Anonymous Referee #1

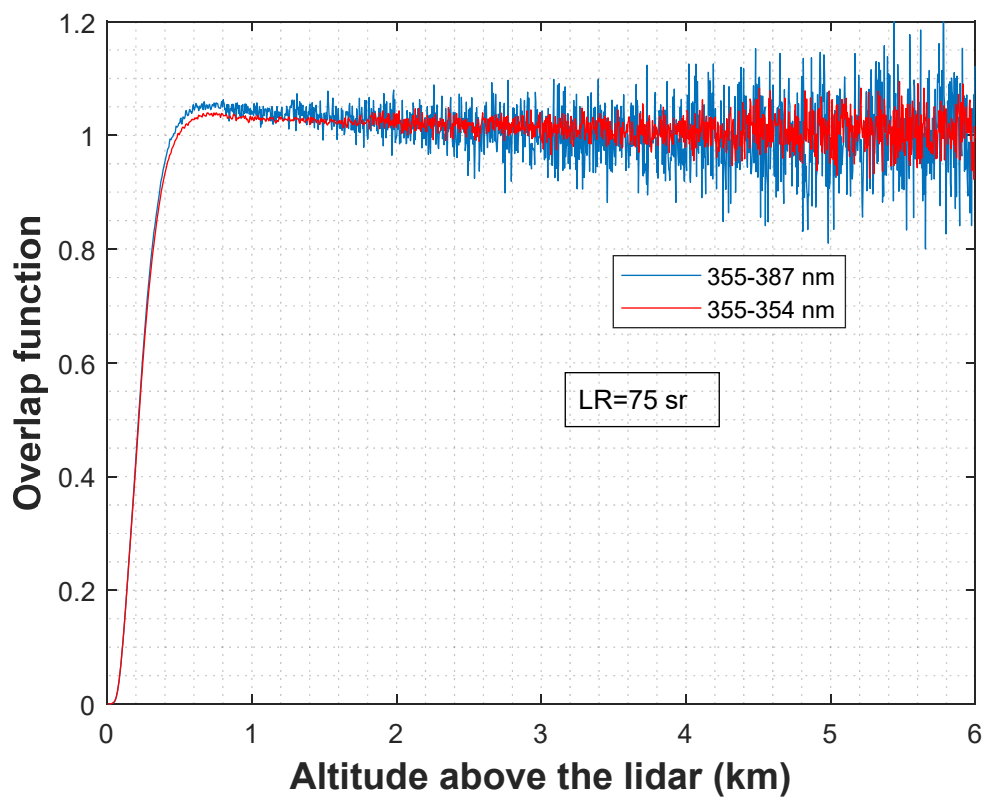
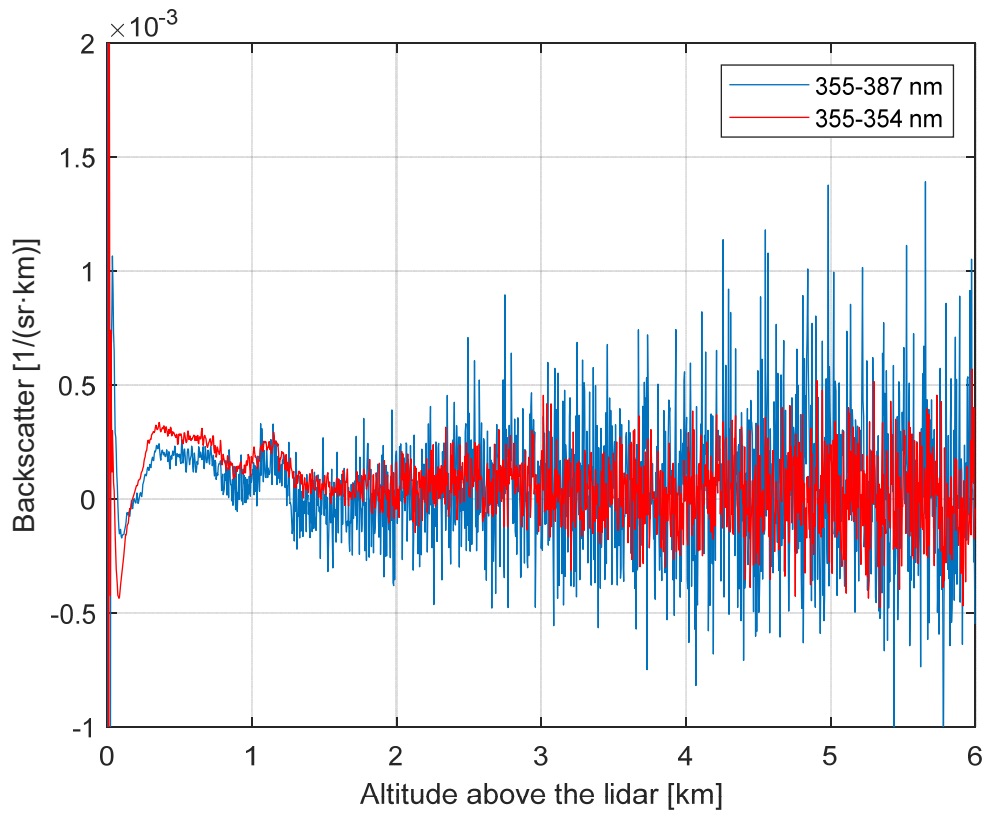
the overlap between the Raman and the elastic channels is indeed the same. Different interference filters (IFF) are applied per channel that can lead to overlap-like effects in the signals as the angle of incidence (AOI) of the collected beam on the IFF changes from the near range to infinity. This is especially important for the Rotational Raman channel because changes in the AOI create an effect equivalent to shifting the IFF transmission with respect to the incident wavelength. Such overlap-like effects are expected to be pronounced in a Rotational Raman channel due to the proximity of the central wavelength of the IFF to the Cabannes line and due to the temperature dependence of the Rotational Raman cross sections.

A good experimental way of verifying this is to check whether the 355-387 derived overlap is the same as the 355-354 one, or whether the Raman backscatter at 355-354nm is the same in the near range as the 355-387 one. For 532-607nm the authors could prove that by using an IFF with a different bandwidth in subsequent measurements they get the same overlap function. Without such a verification I wouldn't recommend publishing the experimental part.

Regarding the comparison proposed by the reviewer: unfortunately

1. The signal at the VBR 387 nm channel is noisier than the signal from PRR 354 nm. The design of the PRR channel has been carefully made as it was reported in (Zenteno-Hernández et al. 2021). Therefore, we have more confidence in the overlap retrieved with the 354 nm.
2. Using the PRR channel in eq 9 minimizes the effect of discarding the difference in atmospheric transmission between the elastic and Raman channels that is applied in the practical calculation of eq 15

As an example, we have computed the Raman backscatter coefficient at 355 and the overlap retrieval with both Raman channels for the Dec 1st measurement. The reference height is 6 km.

Given the noise in the 387 nm channel, we give more confidence to the calculation using 354 nm.
